**Subject: Proposed 9-Lot Subdivision (Tax ID 12004-010)  
Stowe Hollow Road, LLC  
Stowe Hollow Road, Stowe, VT**

**Project #18045**

We are in receipt of a memorandum from Harry Shepard, Town of Stowe Public Works Director, dated February 18<sup>th</sup>, 2020 which includes review of the plans, details, and supporting materials for the above-referenced project.

**EPSC CONSTRUCTION PLAN - PHASE 1**  
RIDGE AT STOWE HOLLOW  
STOWE HOLLOW ROAD LLC  
STOWE HOLLOW ROAD, STOWE, VERMONT

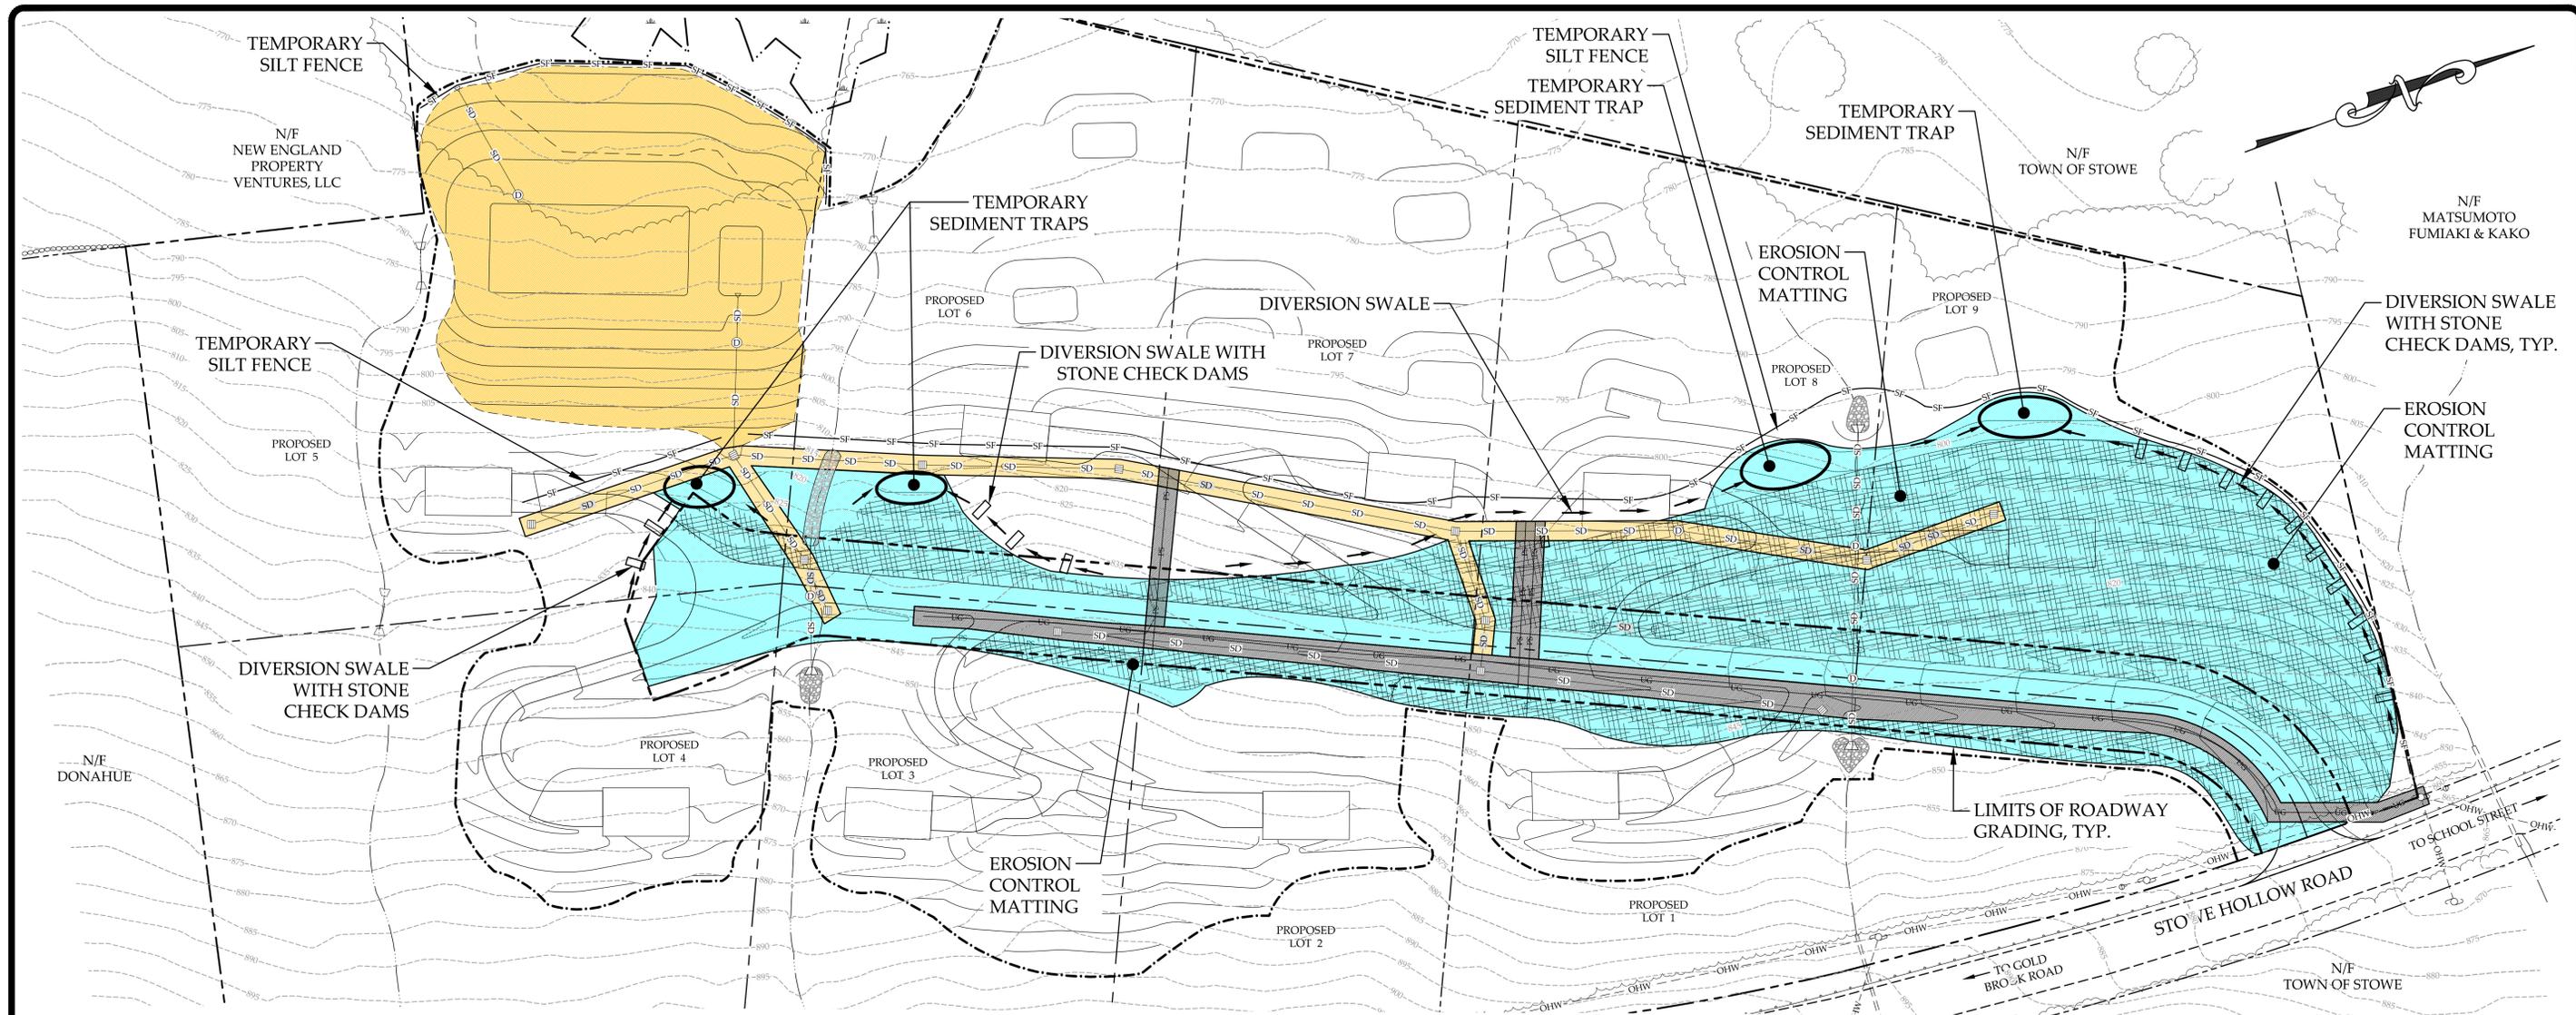
- f. The proposed stage-storage computations utilize the voids within for the depth of the constructed gravel wetlands which is underlain by a liner and intended to normally be saturated for the intended wetland plant functions. If intended to be normally saturated, the voids are not available for storage.

- i. **Response:** In order to account for this difference with measurement of available volumes, the **proposed gravel wetland stormwater pond has changed in size**. Please see attached **revised plans** and associated HydroCAD report for the revised pond size and exclusion of the saturated areas of the pond.

REVISION: 02-26-20 - REVISED SIZE OF GRAVEL WETLAND  
REVISION: 01-23-20 - VARIOUS CHANGES TO PHASES & AREAS

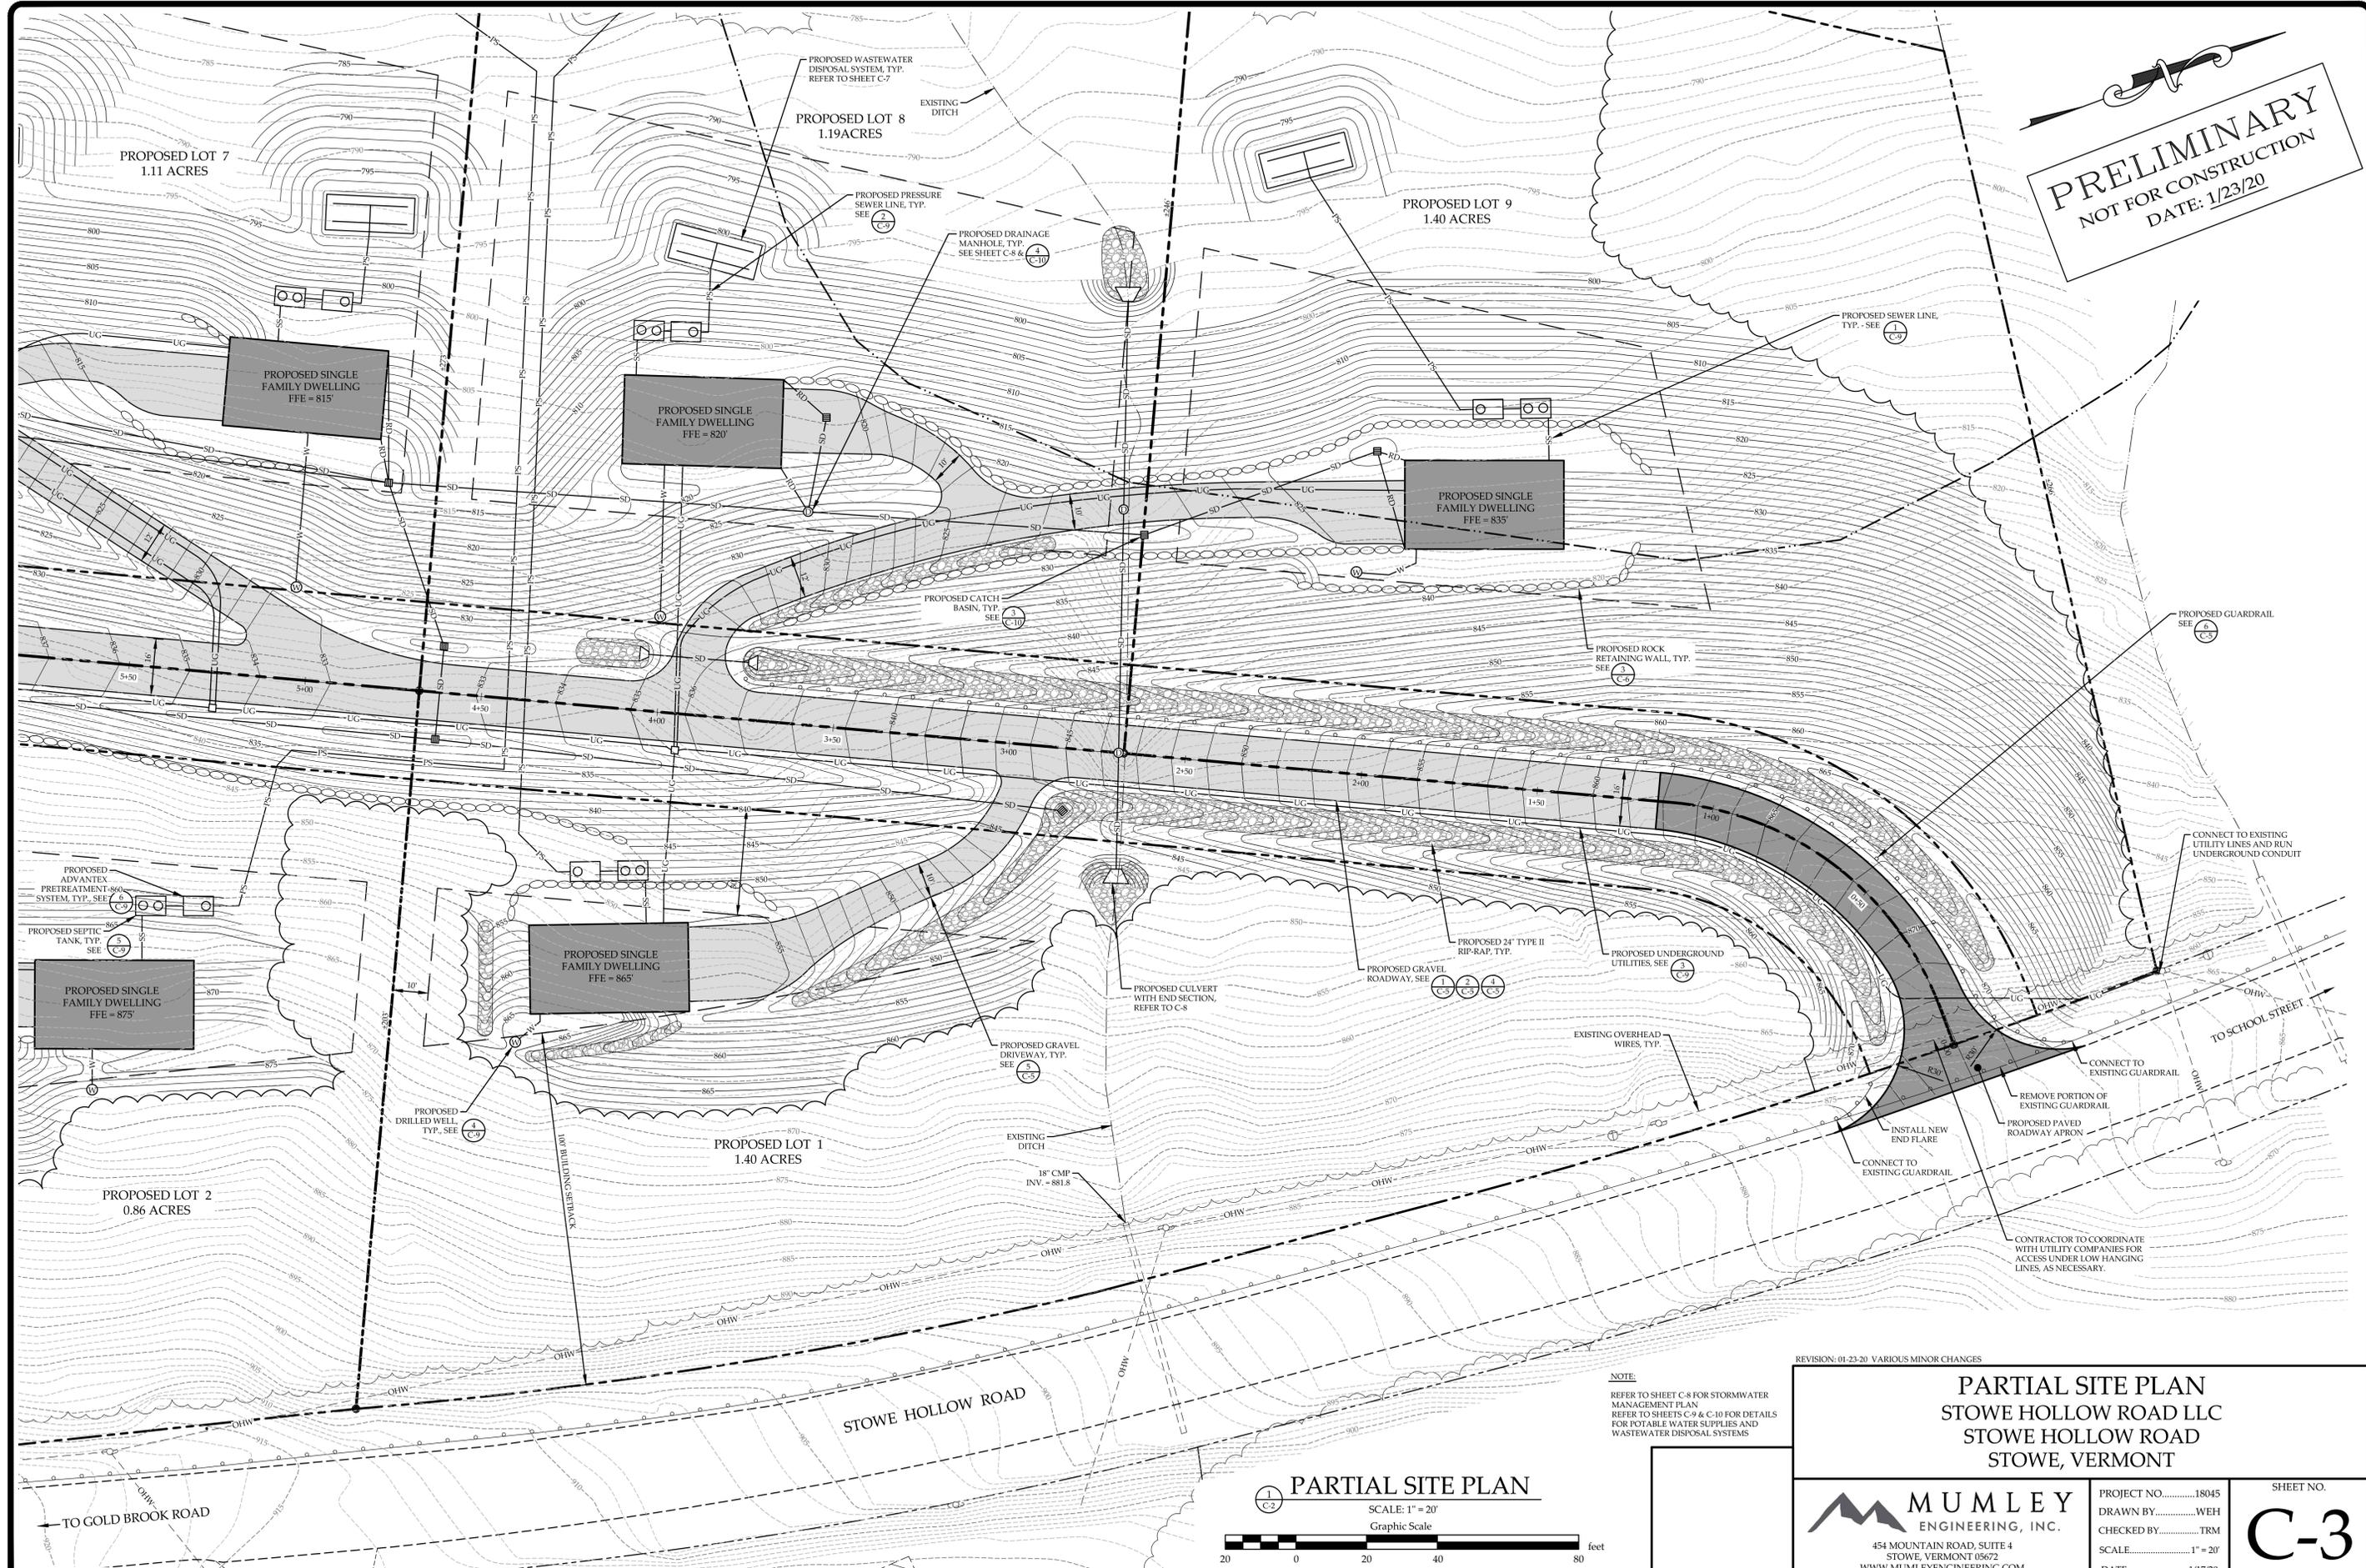
2. *The earthwork notes on sheet C9, which appear to be based on VTrans Standard Specifications, are generally intended for lineal transportation projects. These types of projects generally attempt to balance earthwork quantities and include earthwork sections. They are also generally implemented by a Resident Engineer authorized to make adjustments of grading and materials used where required for the conditions and materials encountered. They would also provide the requisite construction quality control which is extensive for this scope of earthwork operations. This is not the norm for this type of private site development project*

- a. **Response:**
    - i. The attached Construction Specifications booklet will be included as part of the plans.
    - ii. There is a significant amount of fill required for the beginning portion of the new roadway as it connects from Stowe Hollow Road and enters the site. However, once the proposed road meets the existing grade (elevation ~835' at approximate Station 4+00), the roadway construction is generally linear and balanced
